SUBJECT: BWR VENT HEADER CRACKING

CLOSE-OUT OF DIVISION OF LICENSING TASK
ON VENT HEADER CRACKING IN MARK I AND II
BOILING WATER REACTORS

ENCLOSURE
IMPLEMENTATION OF GENERAL ELECTRIC
SERVICE INFORMATION LETTER 402
"WETWELL/DRYWELL INERTING"
BROWNS FERRY NUCLEAR PLANT

BRUNSWICK STEAM ELECTRIC PLANT, UNIT NOS. 1 AND 2
DOCKET NOS. 50-325 & 50-324/LICENSE NOS. DPR-71 & DPR-62
ACTIONS IN RESPONSE TO GE SERVICE INFORMATION LETTER (SIL 402)
CONTAINMENT INERTING

FIGURE 1

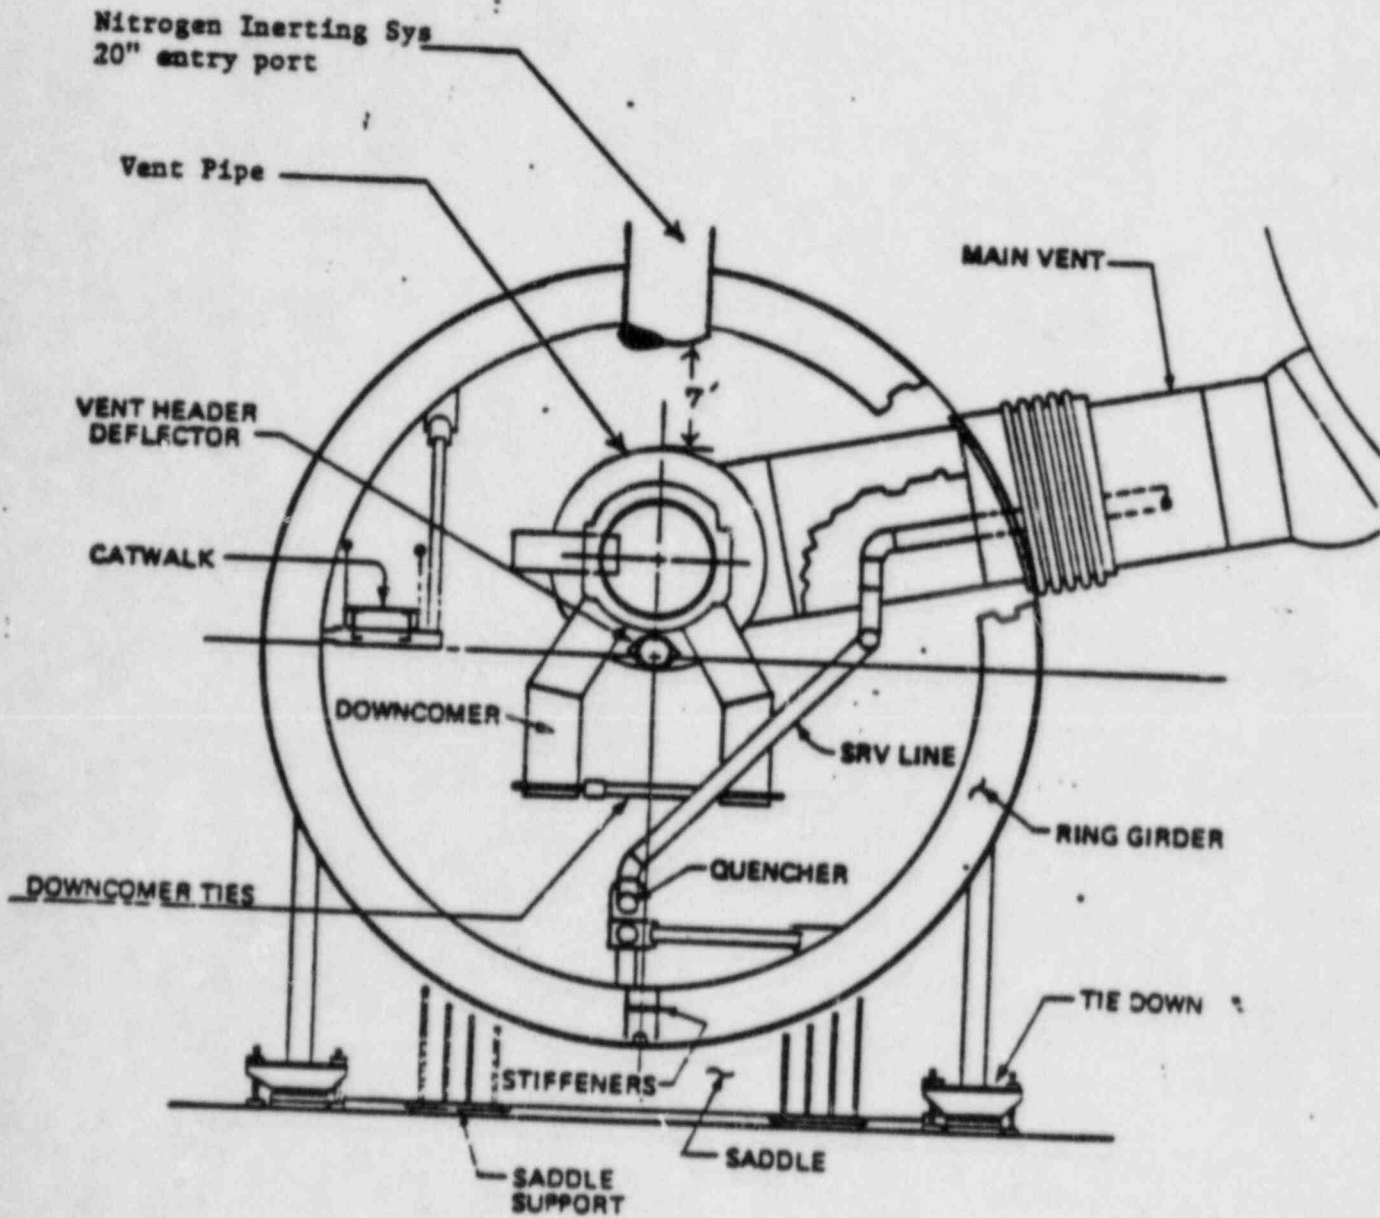
Indicate the location of your
Nitrogen Inerting System entry Port.
